Art Building and Art Building Annex (AB) Abatement and Demolition ITB #1752

Addendum #01

September 9, 2026

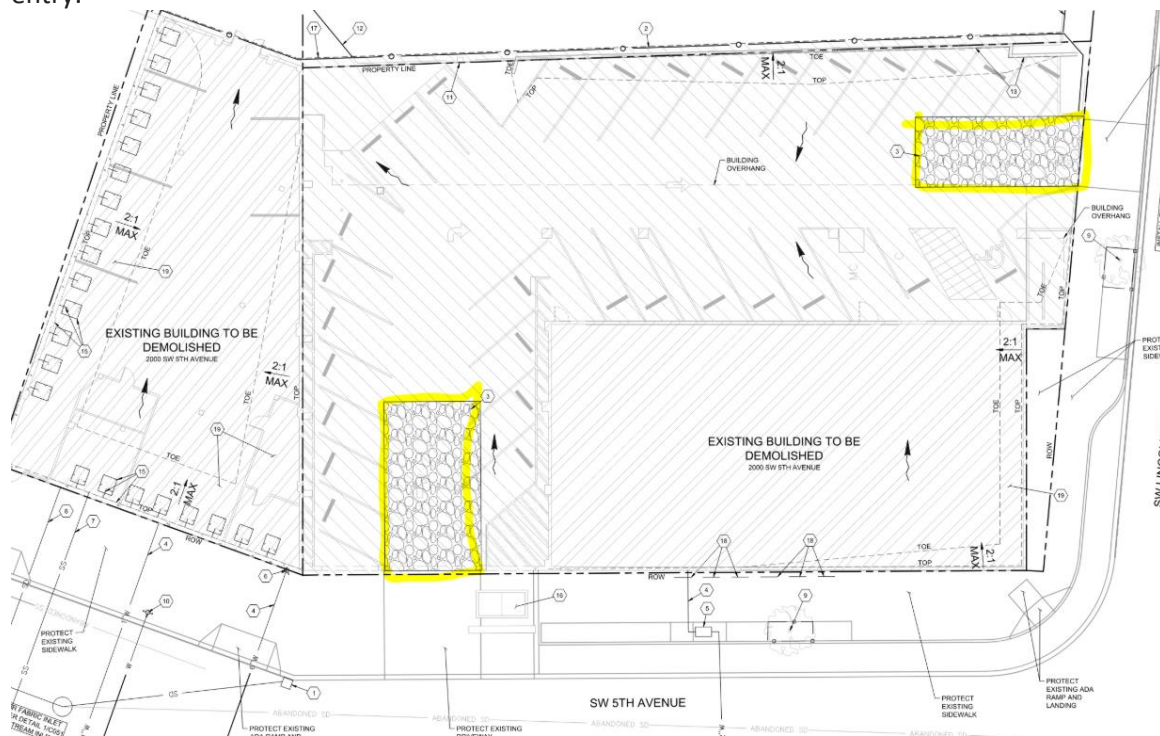
9. **Question:** The City is putting in a skateboard park on the east side of the building that has direct access to the back parking lot of the building to be demolished. We would like the City to allow access to the site for heavy equipment and trucking.

Answer: After discussing with several people within PSU and the people over that project, they will not halt construction. The Civil engineer has the below entries suggested. In the snip, North is to the left. Both options will require temporary road closure permits. The West entry will likely require selective demolition for heavy equipment entry. The South entry would likely require temporary impact to MAX line for heavy equipment entry.
